<h1>HERSCHEL PLANCK</h1>	REF.: <i>HR ASP1-MN-4A</i>
		DATE <i>18-19/04/01</i> PAGE: 1/12

**COMPTE RENDU DE REUNION / MINUTES OF MEETING**      LIEU / PLACE :

*K.O. Instrument I/Face meeting (PACS + SPIRE) / Electrical splinter meeting.*

## POWER

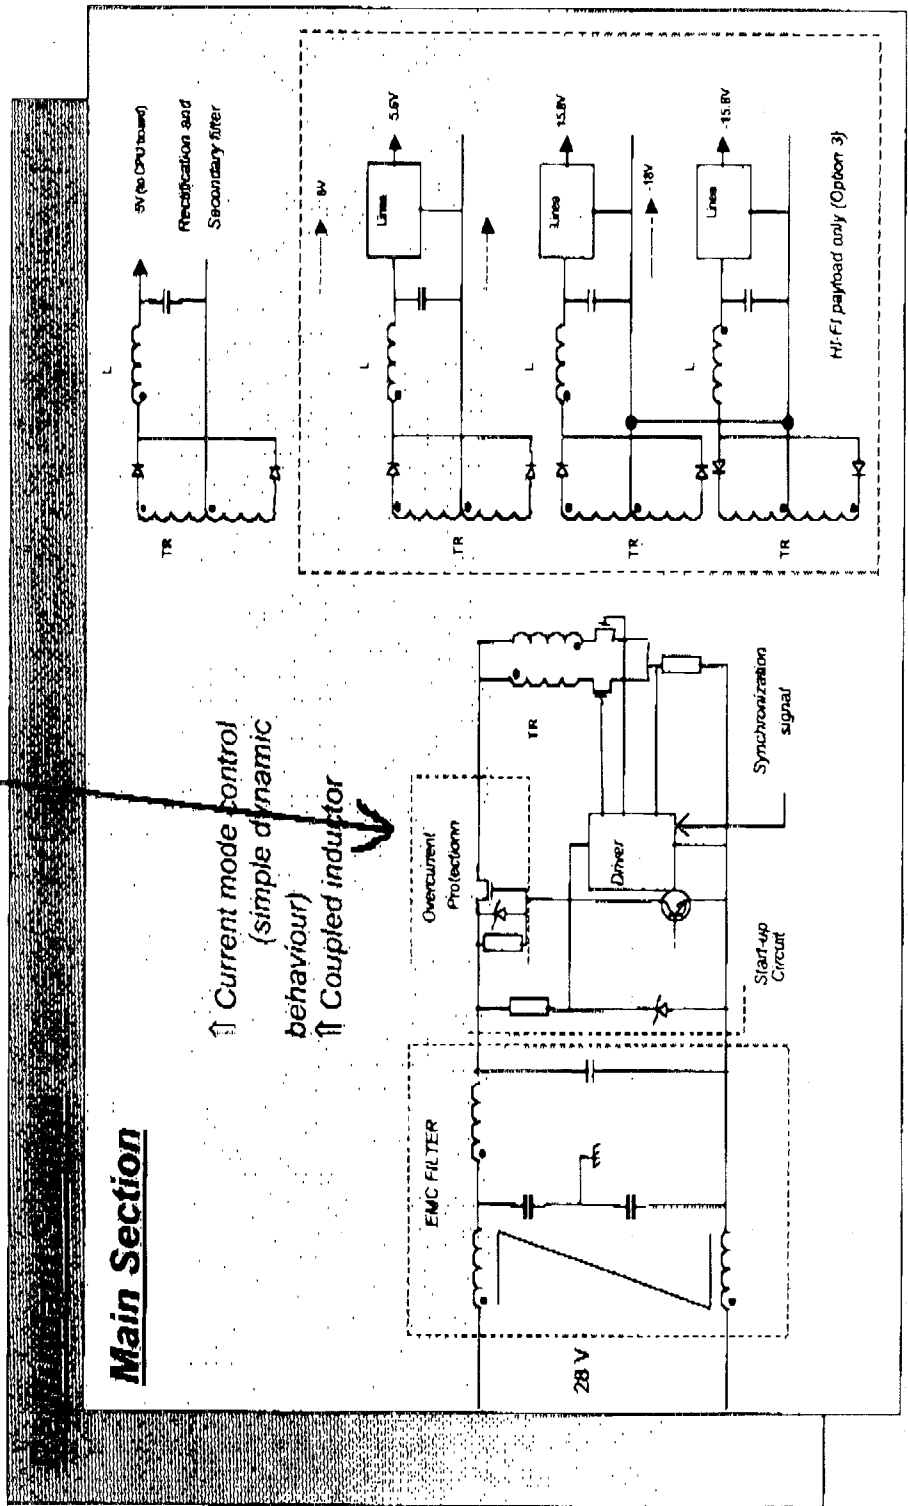
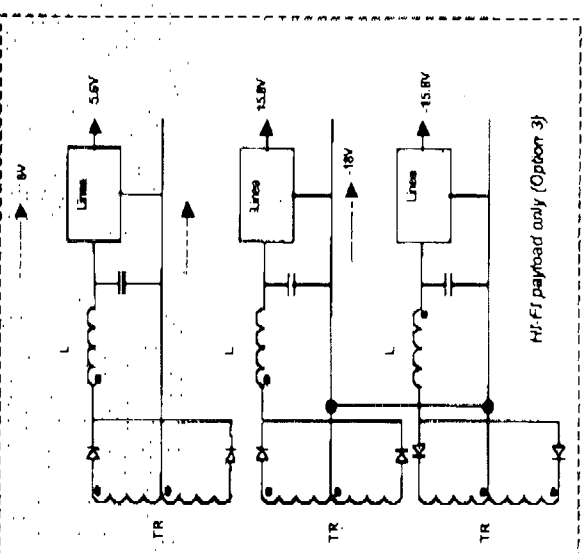
The ICU is used for all 3 Herschel instruments, yet the power budget allocated for this unit varies between 25W to 71W !

The switching, status and current telemetry of the power lines is performed within the PCDU. It is not necessary nor desirable to repeat these functions within each instrument.

It is possible that the PCDU LCL has a failure mode whereby it is permanently ON. Each instrument should evaluate this failure case and state if this is acceptable for the instrument considering functional, power, thermal aspects.
